**Wyoming Outdoor Council  
Upper Green River Valley Coalition  
Greater Yellowstone Coalition  
The Wilderness Society  
Jackson Hole Conservation Alliance  
National Wildlife Federation  
Center for Native Ecosystems**

April 9, 2005

**RE: Comments on February 2005 Draft Environmental Impact Statement for the Jonah Infill Draft Environmental Impact Statement**

Figure 1

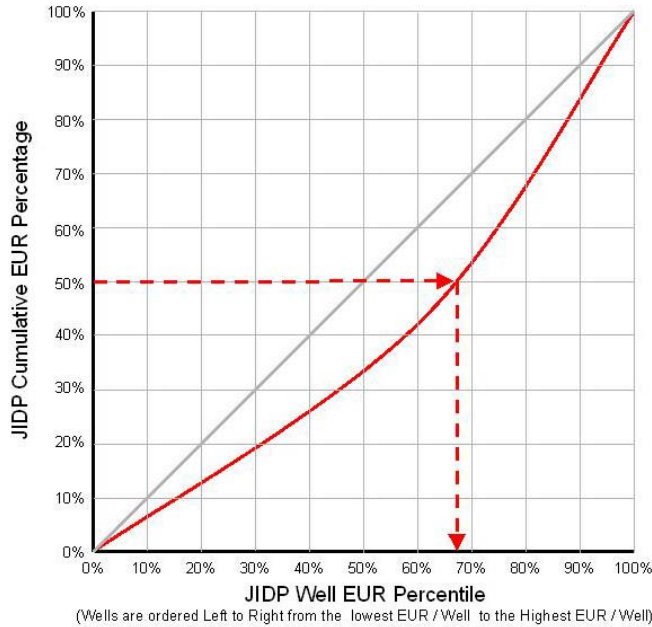
If all the JIDP wells had EUR’s that were nearly equal, then the wells in lowest 10 percentile (i.e. 0% to 10%) would contribute nearly the same percentage to the “JIDP Cumulative EUR” as the wells in the highest 10 percentile (i.e. 90% to 100%), and the graph would resemble a straight line as shown in **Figure 1**.

Figure 2

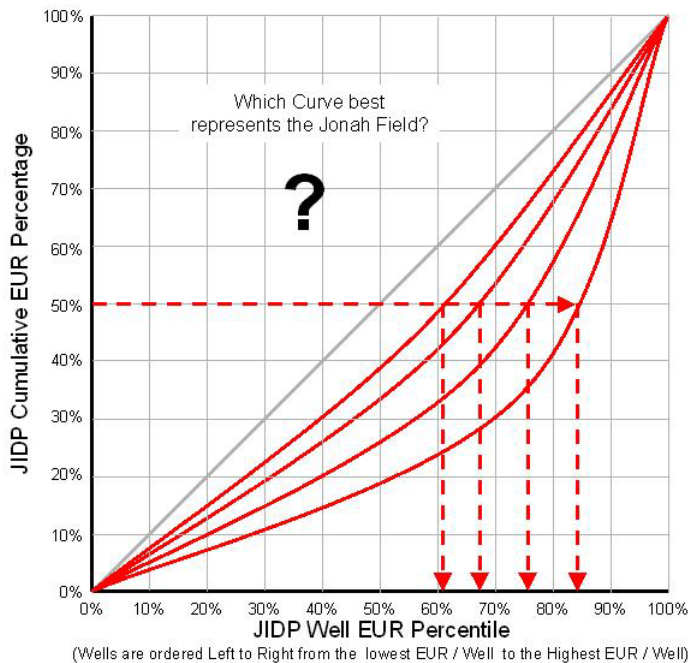
However, as discussed above, the JIDP wells can be expected to have a wide range of EUR's. Therefore, a curve with a shape similar to the one shown in Figure 2 is more realistic.

The curve in **Figure 2** represents the case where the lowest performing two thirds (i.e. 66 percentile and lower) of the well population is contributing only 50% of the total JIDP gas recovery.

Figure 4

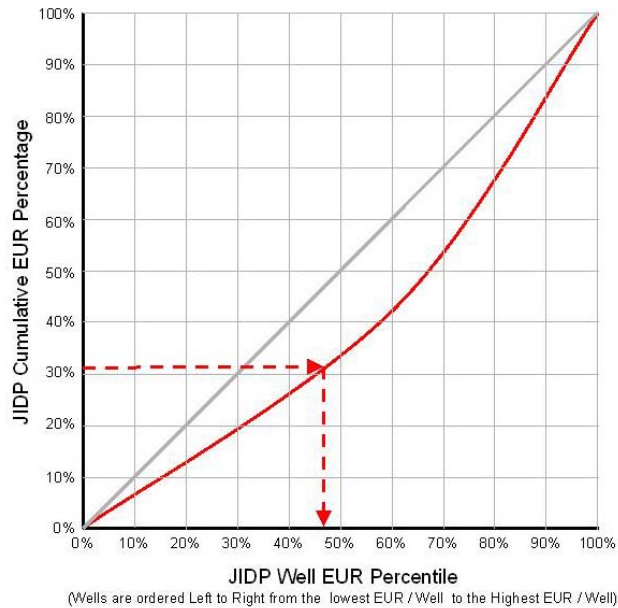
This analysis will assume that the most representative curve is the one shown in Figure 1. The answer to Question #1 can now be determined by reading the graph as shown in **Figure 4**.

In order to produce the 31.8% reduction in recoverable gas reserves, approximately 47% of the vertical wells planned under EnCana’s Proposed Action would have to be assumed to become uneconomical under the directional drilling requirements of Alternative E.

Figure 5  
Distribution of Individual Well Profitability under EnCana's Proposed Action

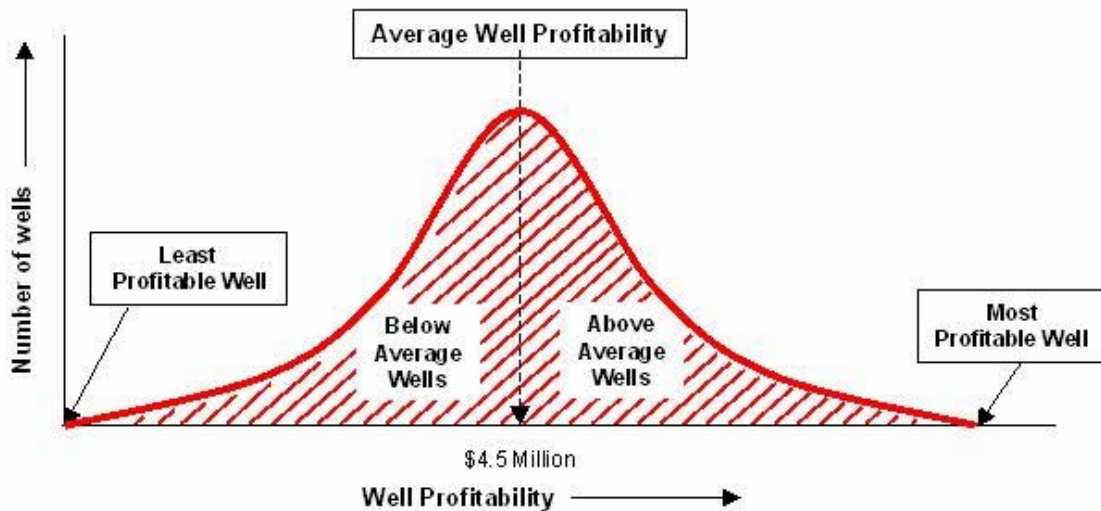
Although the average profitability of wells drilled under EnCana's Proposed Action is estimated to be approximately \$4.5 million, the profitability of individual wells will fall within a range that is centered on this average number. The range of well profitability results from varying gas recovery per well and differences in costs incurred in drilling and completing each well. Most wells will produce a profit that is relatively close to the estimated average well profit. Relatively few wells will have profits that are either significantly higher or significantly lower than the average well profit. This distribution of well profitability is illustrated by **Figure 5**.

Figure 6

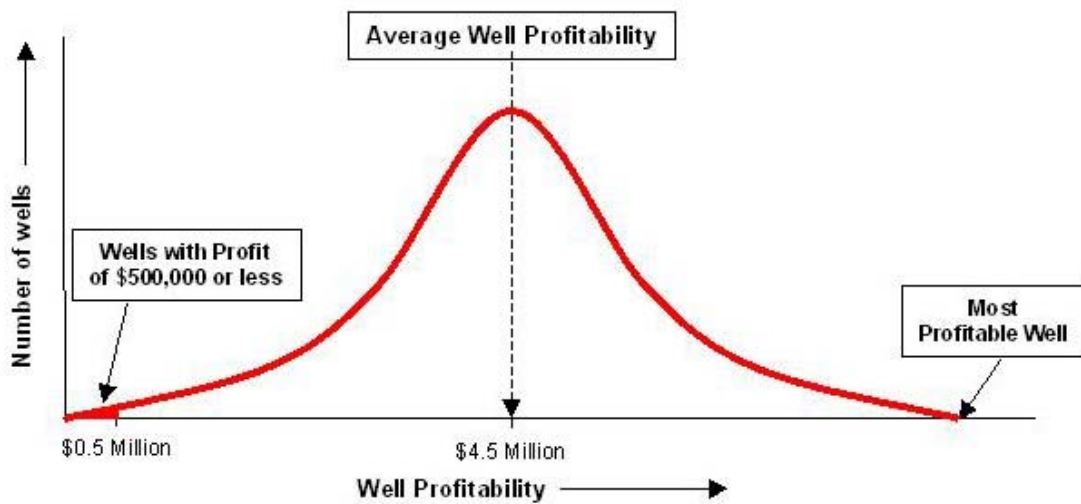
Given this normal distribution of well profitability, only a very small percentage of the wells drilled under EnCana's Proposed Action could be expected to have a profitability of \$500,000 or less. The probability of any given well having a profitability equal to, or less than, a particular dollar amount is proportional to the ratio of the area under the curve and left of the dollar amount

to the total area under the curve. In Figure 6, it can be seen that the shaded area to the left of \$500,000 is very small in relation to the total area under the curve.

It is statistically impossible that more than a couple percent of the wells planned under EnCana's Proposed Action could be expected to have a profit margin of \$500,000 or less.
